Technical Bulletin: A-FRZ Jumper Selection

Rev.: 05 May 2015K
 P/N: TB15.001

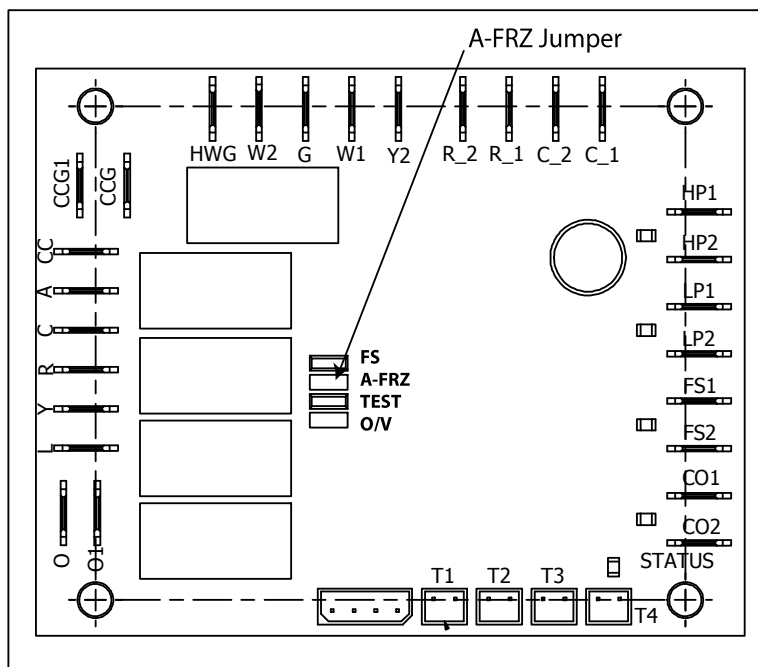
This technical bulletin is to help notify all installers to remove the A-FRZ jumper from the YT, VS, and VT lockout board for closed loop applications. If the A-FRZ jumper is not removed the lockout board will initiate a fault when the source temperature reaches 30°F. Once the jumper is removed, the lockout source temperature is lowered to 15°F. The lower source temperature is required for closed loop applications with antifreeze. See the location of the A-FRZ jumper on the lockout board drawing below. Also, the tag below will be added on units no later than June 2015.

The A-FRZ jumper on the Lockout Board **MUST** be removed for closed loop applications, but **MUST** remain installed for open loop applications.
